Purpose: The purpose is to fix issues with assertion VPI diagrams.

REPLACE in 36.11 Scope (note to editor: only affected parts are shown)

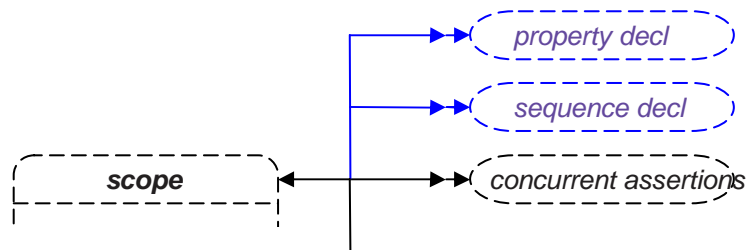
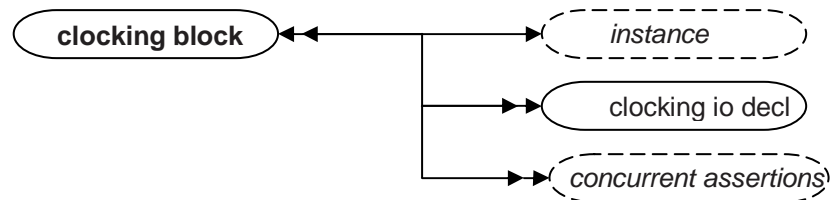
4. The issues of a) not being able to access properties and sequences that are not instantiated and b) not being able to determine the scope in which they are defined was fixed. Specifically, property declaration and sequence declaration was added to the 36.11 scope diagram and to the clocking block diagram. In the process, it was also noticed that the clocking block diagram should not have had concurrent assertion so that was removed (you can declare properties and sequences in clocking blocks but not assert them).

REPLACE in 36.43 Concurrent Assertions (note to editor: only the part that changes is shown)

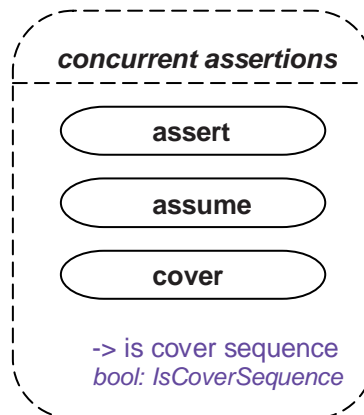
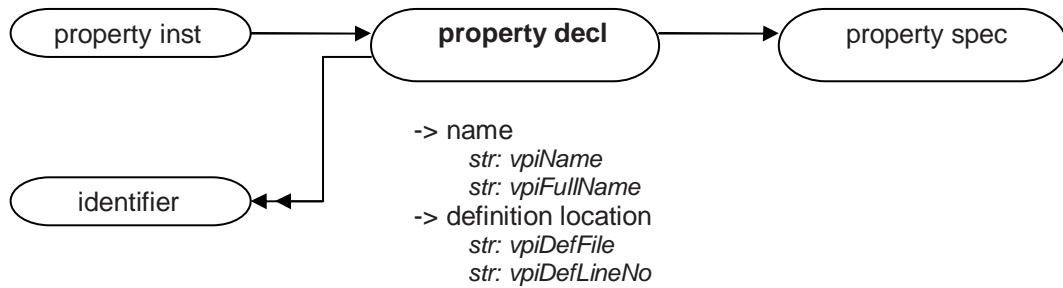
5. There is overlap in the definition of `vpiDefLineNo` and `vpiDef`. Add a note that they are the same for property and sequence declarations.
6. 'block identifier' makes no sense for sequence and property declarations. These are not 'labeled statements'. In diagram 36.43 and 36.46, 'block identifier' should be replaced with 'name'.

10. bool: `vpiIsCoverSequence` was added under cover on diagram 36.43 for distinguishing cover property and cover sequence (missed in Mantis 1768)
11. Added a note to the editor to make the Immediate assertion a section of its own instead of being included with the `sequence_expr` diagrams in 36.47.

-> definition location
str: vpiDefFile
int: vpiDefLineNo
-> ~~block identifier~~ name
str: vpiName
str: vpiFullName
-> is clock inferred
bool: vpilsClockInferred

IN 36.44 Property Declaration REPLACE

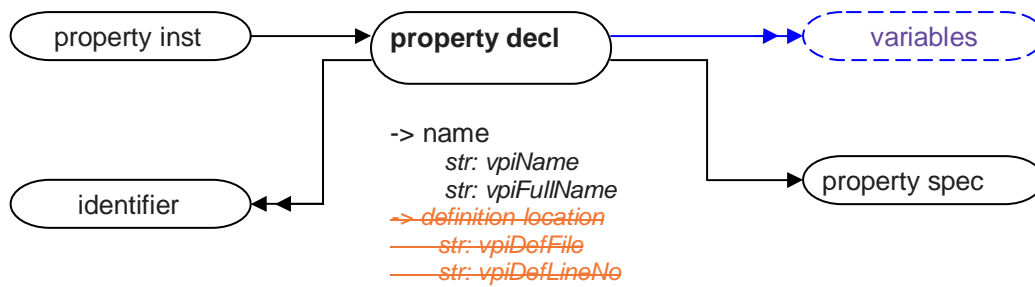
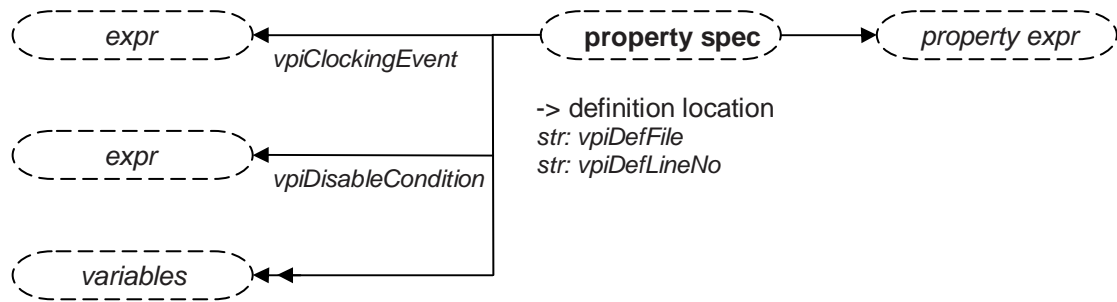
1. Clarify that `vpiIdentifier` iterator in the property and sequence declaration shall return the list of arguments in the declaration.
2. Add `vpiArgument` as an iterator to properties similar to sequences.

3. `vpiArgument` should be a `property_expr` for property instances and a `sequence_expr` for sequence instances (missed in Mantis 1730)
4. In several diagrams `vpiDefLineNo` is a “str”. This should be an “int”. It affect 36.44, 36.45, 36.46, 36.48.

1. [JV] Per Jim's discussion, the notes for each callback were replaced with a paragraph at the end that states what is possible.
2. variables was moved from property spec to property declaration, which is consistent with the BNF and examples in the text.

3. vpiDefFile and vpiDefLineNo were deleted from property declaration and sequence declaration and the note added: **vpiDefFile** and **vpiDefLineNo** are deprecated because they are the same as **vpiLineNo** and **vpiFile**

- 1) The **vpiIdentifier** iterator shall return the property declaration arguments in the order that the formals for the property are declared.
- 2) **vpiDefFile** and **vpiDefLineNo** are deprecated because they are the same as **vpiLineNo** and **vpiFile**.

IN 36.46 Sequence declaration REPLACE

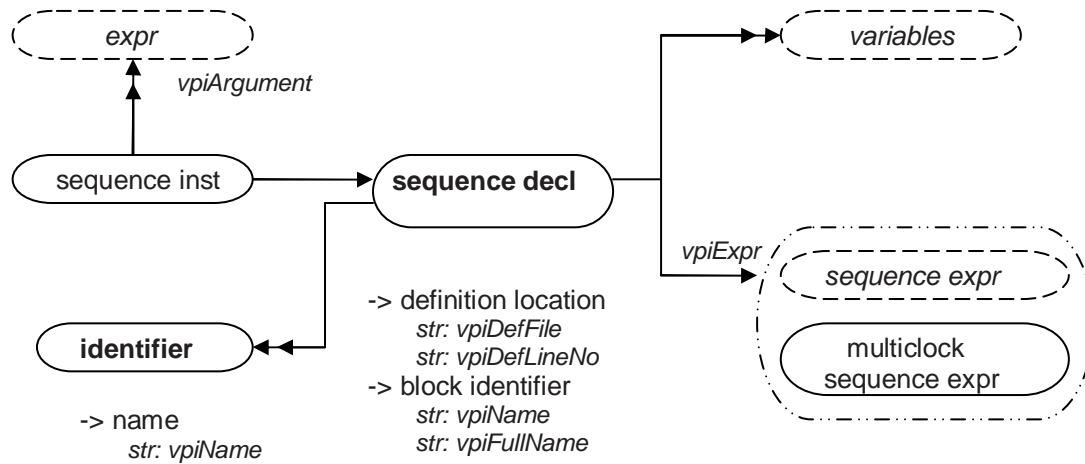
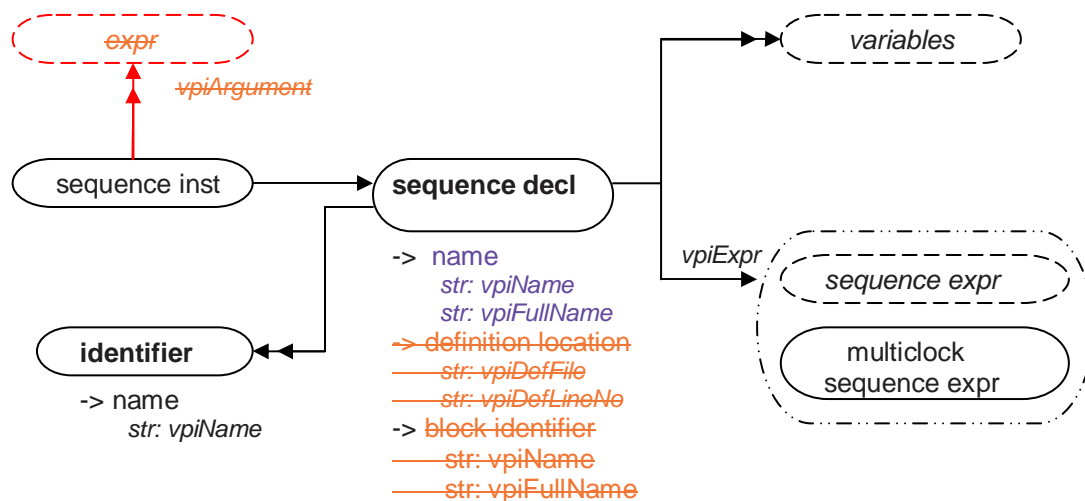
7. `vpiArgument` should only come out of the sequence and property instance where they are defined (definitions are bold), so they should not be shown in the declaration diagrams.

1) The **vpiIdentifier** iterator shall return the sequence declaration arguments in the order that the formals for the sequence are declared.

2) **vpiDefFile** and **vpiDefLineNo** are deprecated because they are the same as **vpiLineNo** and **vpiFile**.

REPLACE in 36.47 Sequence Expression (only affected parts of the diagram are shown)

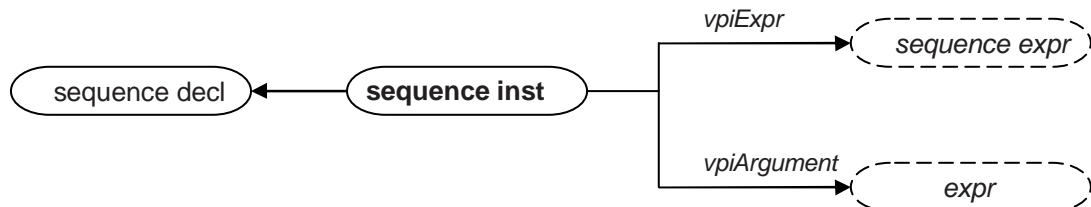
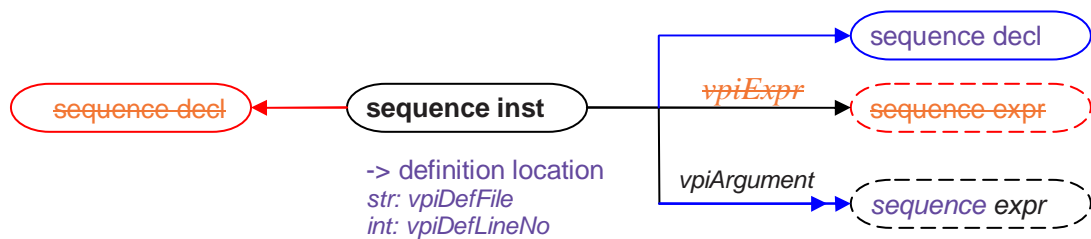
18. [DK] Updated 36.47 to remove the top sequence expr and re-position sequence declaration so the diagram looks like property inst.

1) The **vpiArgument** iterator shall return the sequence instance arguments in the order that the formals for the sequence are declared, so that the correspondence between each argument and its respective formal can be made. If a formal has a default value, that value shall appear as the argument should the instantiation not provide a value for that argument.

Move from “36.47 Sequence expression” the immediate assert definition to a new section titled “Immediate Assertions” that follows 36.48. The notes in 36.47 still remain only in 36.47 – they do not get copied. Note that immediate assume and immediate cover from Mantis 1729 will also reside in this new section. Re-number subsequent sections accordingly.

REPLACE from 36.48 Multiclock sequence expression (only the parts that change are shown)

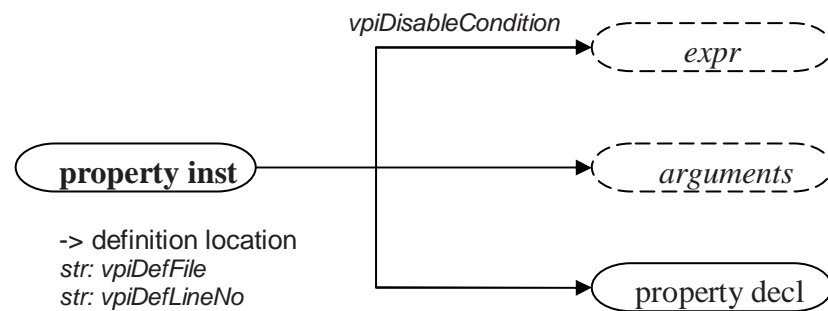
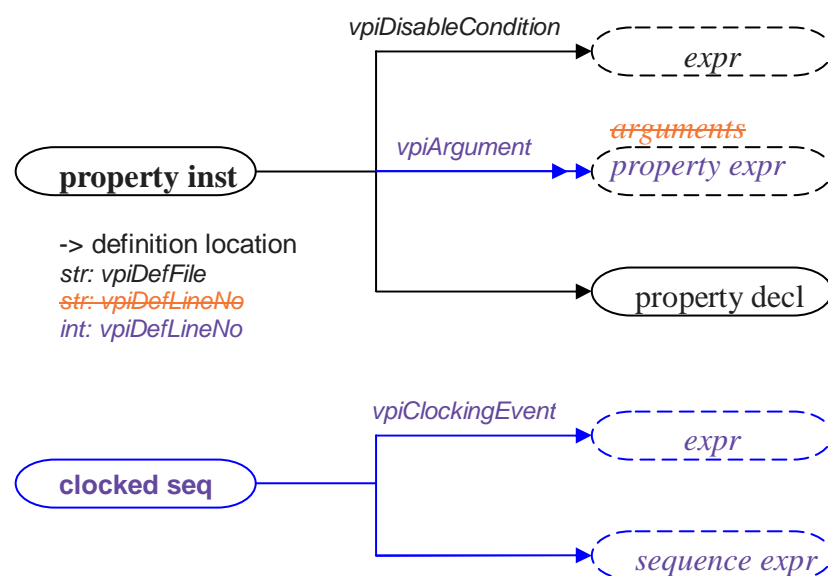
13. Added `vpiClockedSeq` diagram to 36.48

1) The **vpiArgument** iterator shall return the property instance arguments in the order that the formals for the property are declared, so that the correspondence between each argument and its respective formal can be made. If a formal has a default value, that value shall appear as the argument should the instantiation not provide a value for that argument.
